Access Compliance Report

Public Rights-of-Way

(Curb Ramps)

Intersection ID: 11114	Main Street: AVENSONG_CROSSING_DR	Cross Street: CAMP_STEWART_RD	Location: SW
ADA ID: A2DB6ECC1008	Ramp Type: Perp	Initial Pass/Fail: Fail	Overall Compliance: No
Severity Score: 33.75			
Codes/Mitigation Info/Possible Solution		Field Measurements/Component Compliance

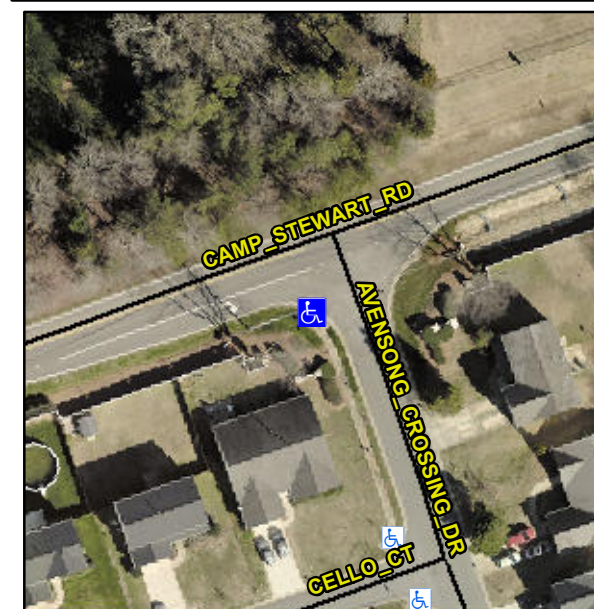
Not Found, R304.5.1, R304.5.3

Compliance	Description	Data	Compliance	Description	Data
N/A	Ramp Length (in)	46.5	Yes	Ramp Slope (%)	6.5
No	Ramp Width (in)	44.5	No	Ramp XSlope (%)	8.0
N/A	Flare Type LT	N/A	N/A	Flare Type RT	N/A
N/A	Flare Slope LT (%)	N/A	N/A	Flare Slope RT (%)	N/A
N/A	Flare Traversable LT?	N/A	N/A	Flare Traversable RT?	N/A
N/A	Landing Length (in)	N/A	N/A	DWS Provided?	N/A
N/A	Landing Width (in)	N/A	N/A	DWS Contrast?	N/A
N/A	Landing Slope (%)	N/A	N/A	DWS Length (in)	N/A
N/A	Landing X Slope (%)	N/A	N/A	DWS Full Width?	N/A
N/A	Landing Curb? (Y/N)	N/A	N/A	DWS Offset (in)	N/A
N/A	Shared Landing?	N/A			
N/A	Gutter Ponding?	N/A	N/A	Gutter Slope (%)	N/A
N/A	Gutter Lip Ht (in)	N/A	N/A	Gutter X Slope (%)	N/A
N/A	Painted X Walk1?	No	N/A	Painted X Walk2?	N/A
	X Walk 1 Direction	To N		X Walk 2 Direction	N/A
N/A	X Walk 1 Width (in)	N/A	N/A	X Walk 2 Width (in)	N/A
	X Walk 1 Slope (%)	0.1		X Walk 2 Slope (%)	N/A
	X Walk 1 X Slope (%)	0.1		X Walk 2 X Slope (%)	N/A

Remove & Replace Entire Ramp.
